Technical Bulletin

Potential lockout condition with revision "B" controls

Tech Bulletin #: TB09.002

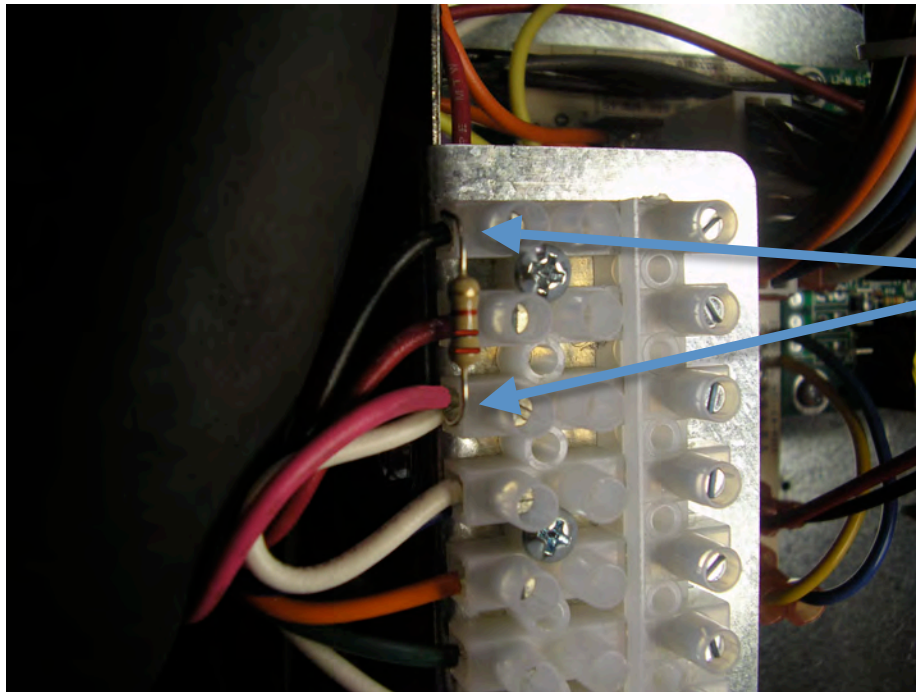
The cause of this behavior is back feed voltage from the ECM fan motor. In some cases, depending upon the line voltage and the quality of power, the back feed voltage may be enough to energize the lockout board, thereby engaging the compressor relay that sends 24VAC to the compressor contactor coil. We have not been able to duplicate the condition in our Greenville location. Therefore, we do not expect this condition to occur on any widespread basis. Our board vendor has made a change to the lockout board to avoid any future potential issues.

The plant in Mitchell has made the change to all units currently shipping. The warehouse in Greenville is adding the change to all units in stock. All units shipping now include the modification. Below is a picture of the new lockout board.

1k Ohm resistor
(1/2 Watt) added
at the plant to
eliminate back
feed voltage
